PROJECT TITLE
80 E
OLENTANGY
POWELL, OHIO 43065

PROJECT NO. SJM_2010
ISSUE FINAL P&Z APPLICATION
ISSUE DATE 04.21.2021
SHEET TITLE

Gretchen Bonasera is proposing to renovate and expand the current building, converting the existing home to a private social club featuring rare bourbons, fine wines, and chef inspired cocktails with just enough small plates of food served to imbibe responsibly. We anticipate our club to be used as a place to gather for business or social, and to be a great place to come before or after dinner plans at one of the great local restaurants Powell has to offer.

The purpose of this document is to address comments from previous meetings and/or staff reports from the City of Powell Planning Staff, the Historic Downtown Advisory Commission and Liberty Township Fire Dept...

SHEET TITLE
**BUILDING
ELEVATIONS**

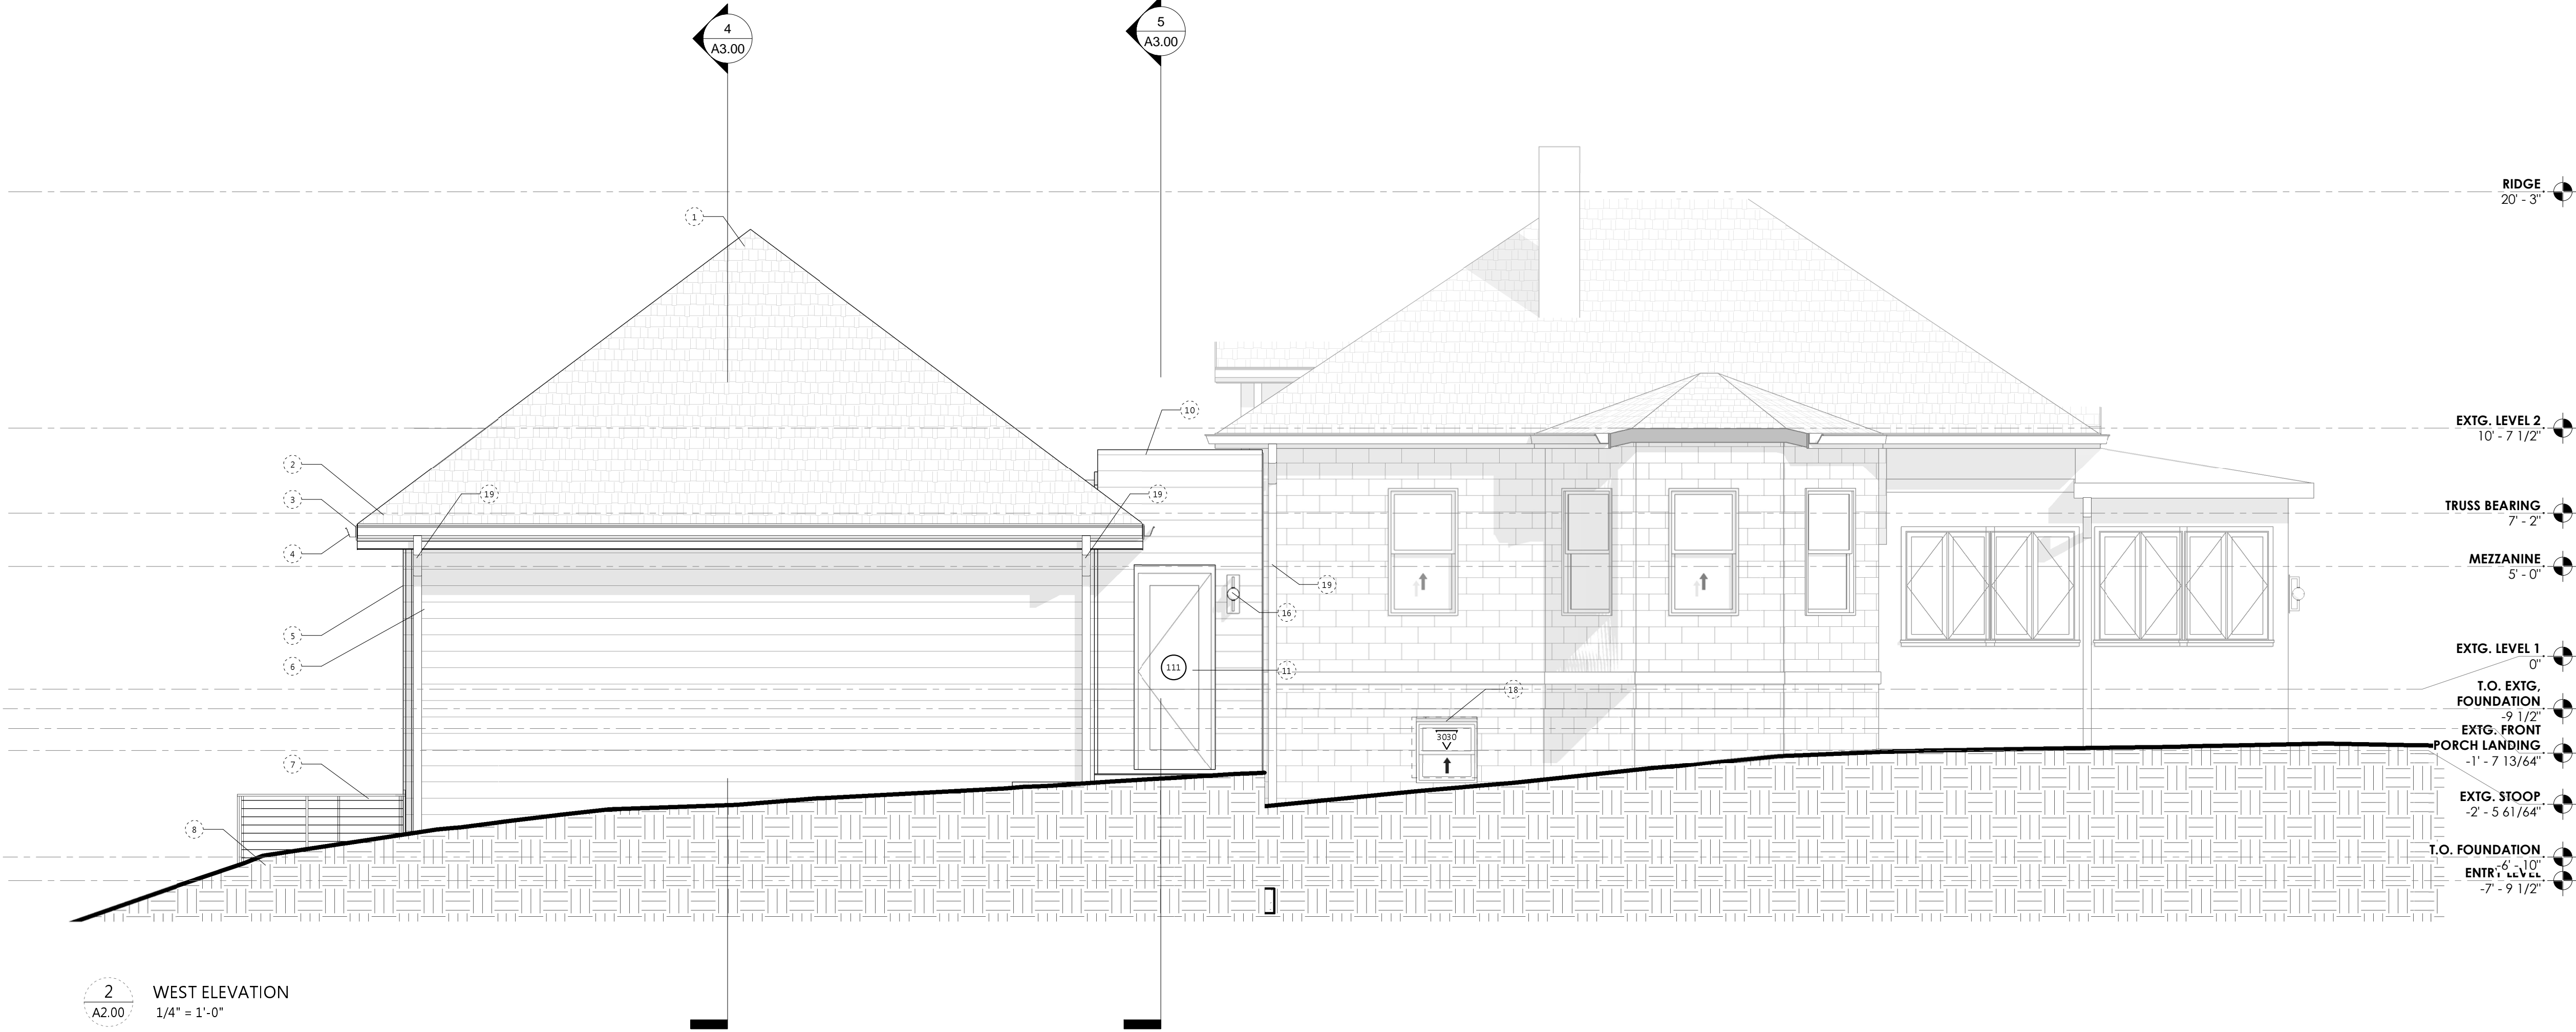
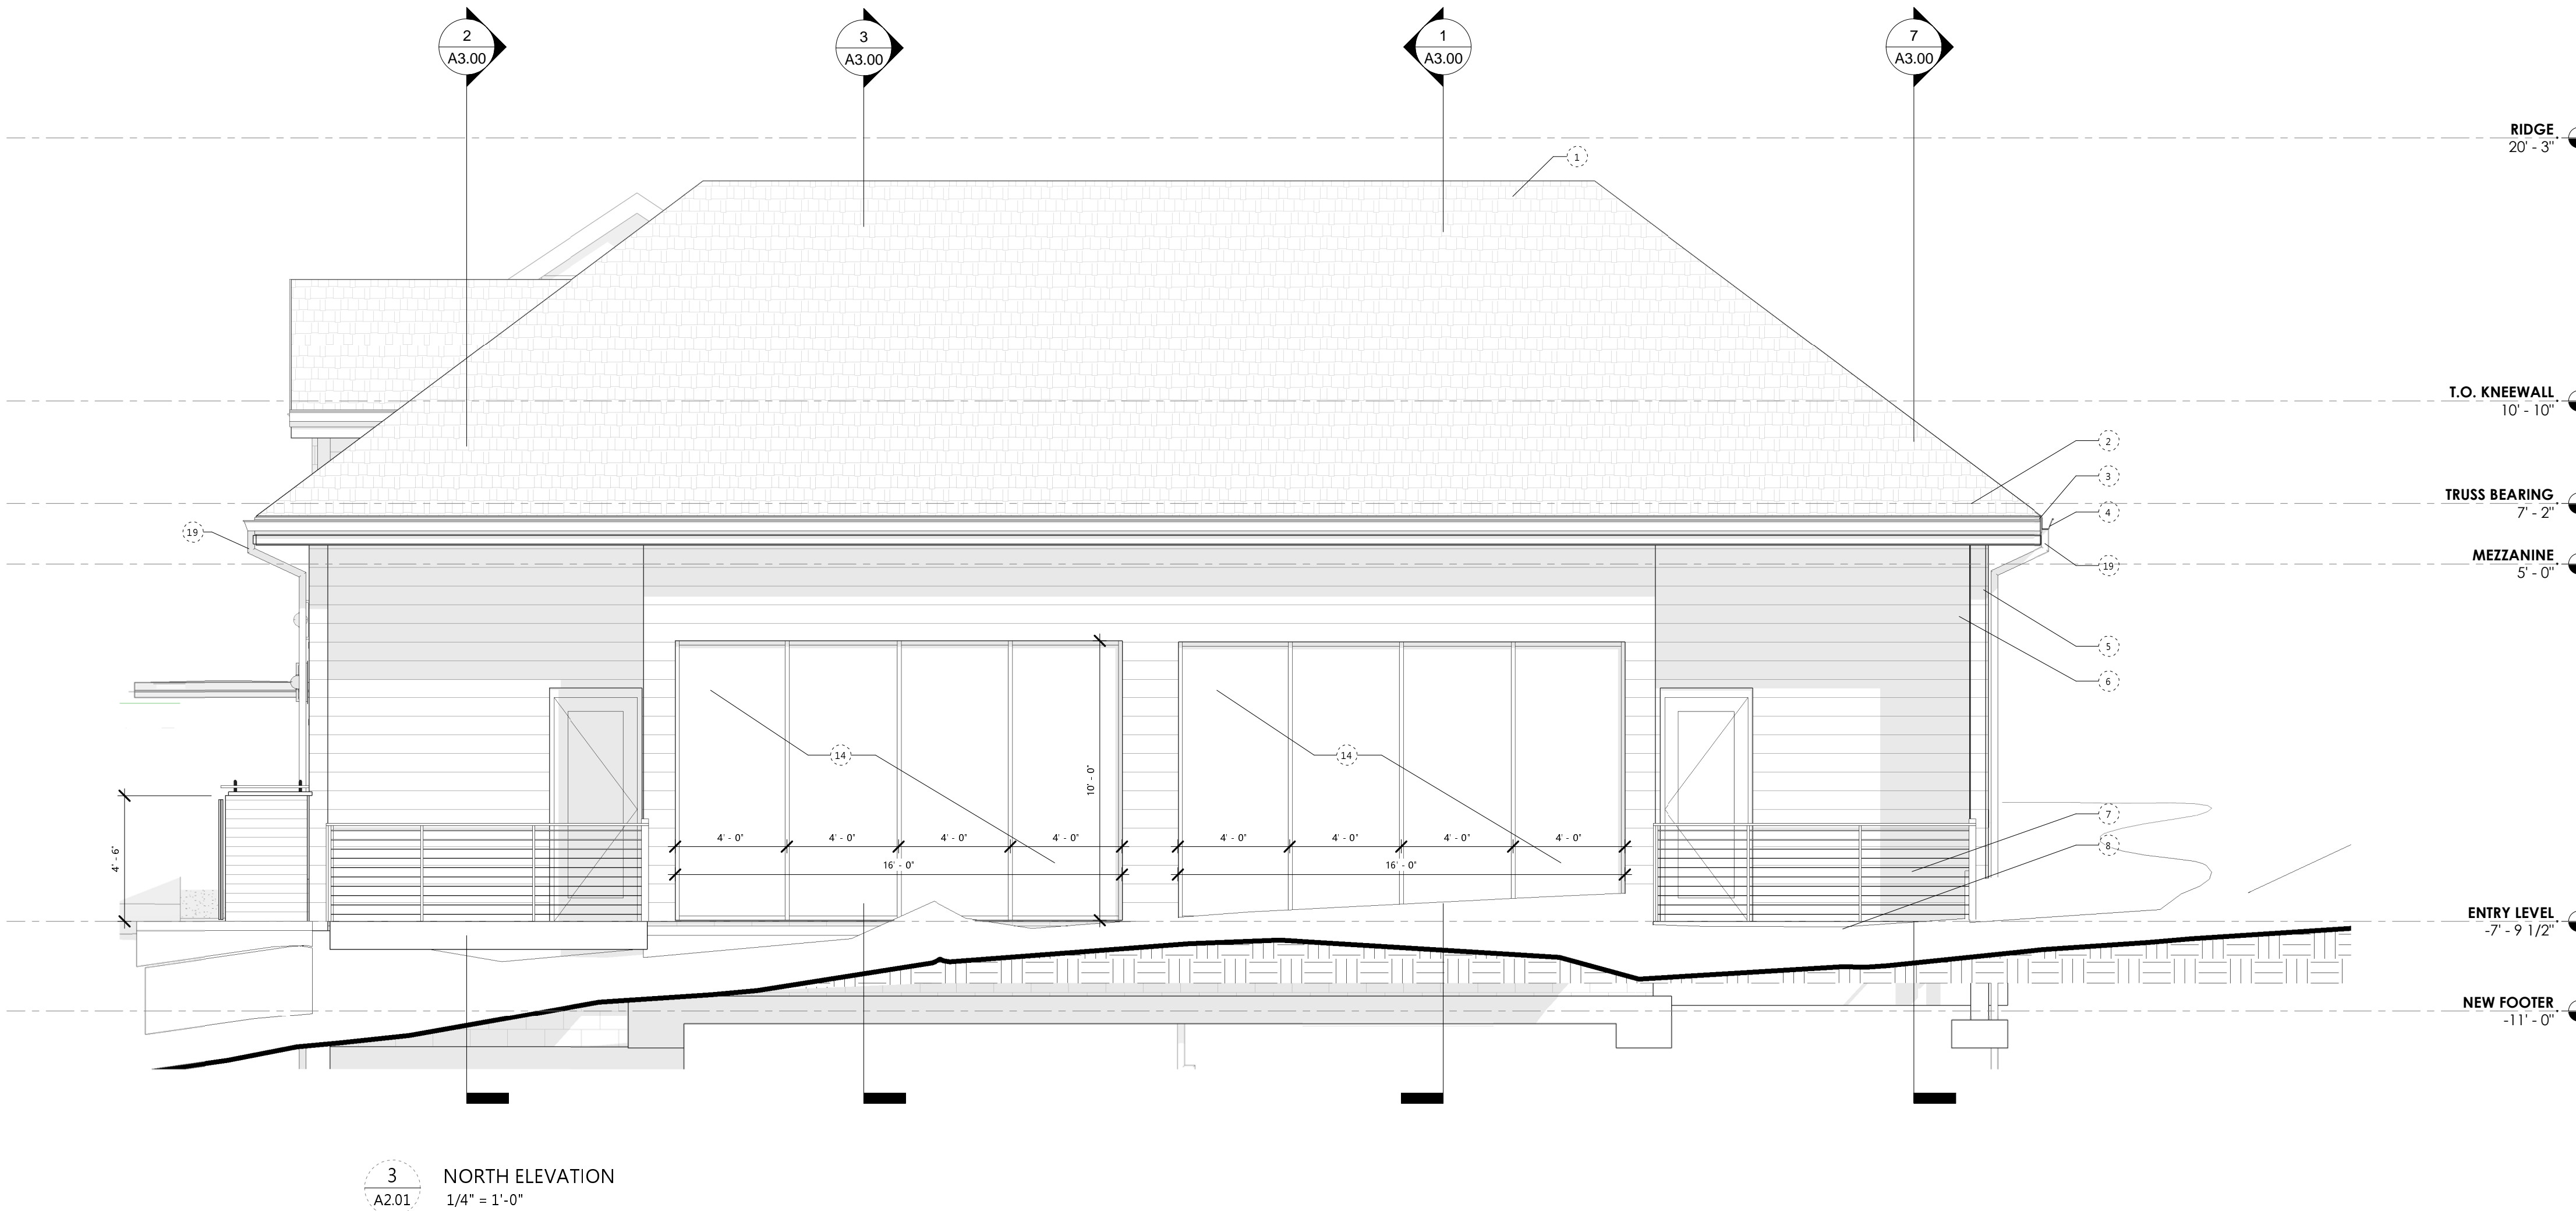
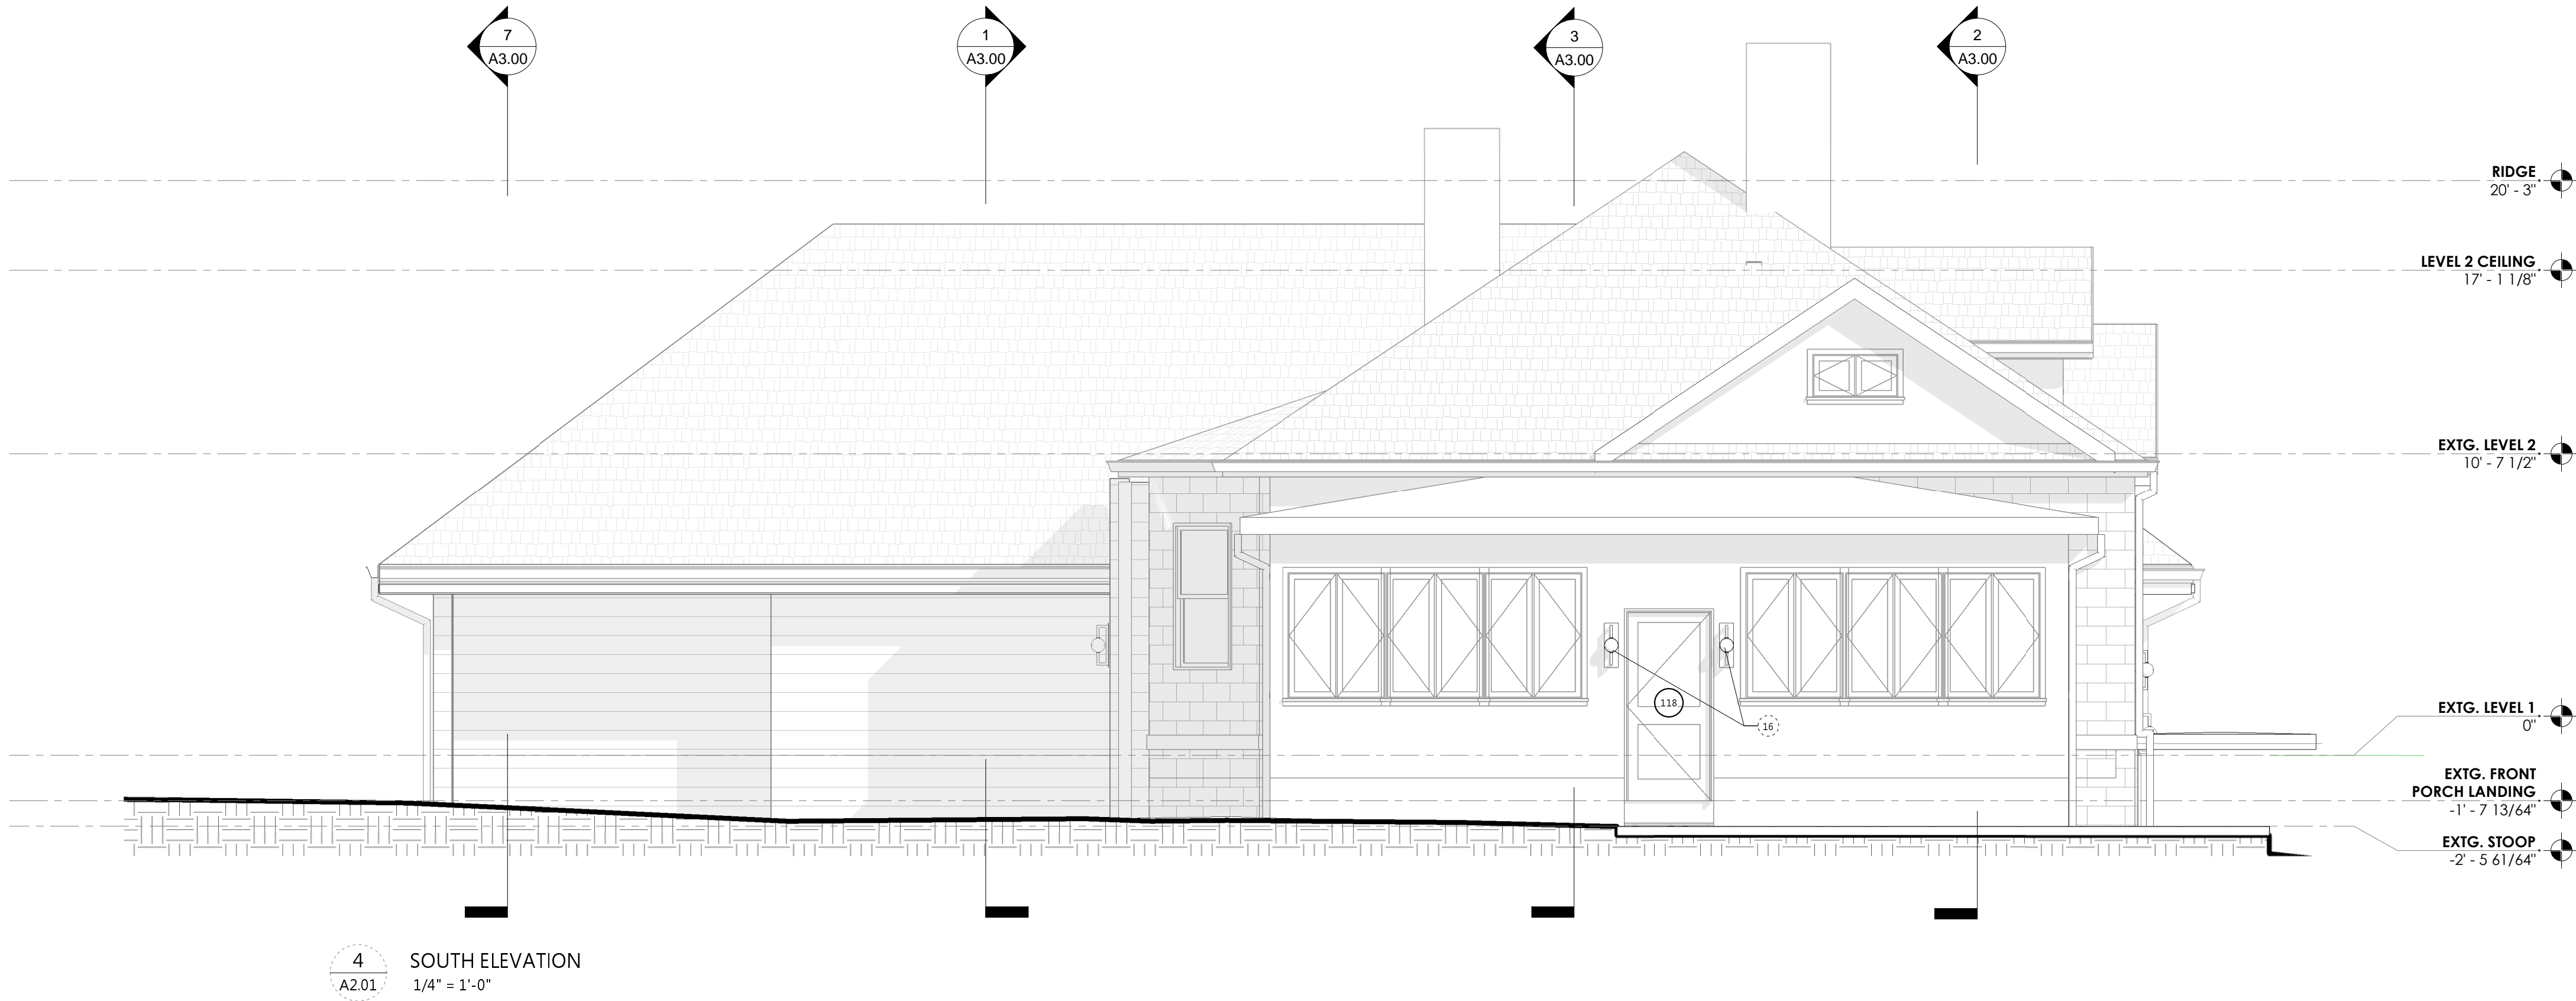
Staff Comment: Staff requests additional detail for the windows, as they appear to lack consistency with the architectural guidelines, or match the window proportions or style of the existing home.

Additional HDAC comment: Tom Coffey wanted us to continue the grid lines of the front windows to the rest of the house.

Staff Comment: The applicant has not provided sufficient information to determine where the gutters and downspouts are located. The color and material of the gutters and downspouts are not included in the submission. The gutters and downspouts should be located as unobtrusively as possible, and should match those of the existing home.

HDAC comment: Tom Coffey requested half round gutters.

The windows in the addition do not mimic the double hung sash style of the residential structure due to various criteria including the interior floor plan and floor to floor height. However, their style does tie into the square window panes of the casement windows in the dormers of the house.

Our Design: *We will follow the staff comment citing PAG p.68. As to placement, the downspouts have been added to building elevations for reference.*
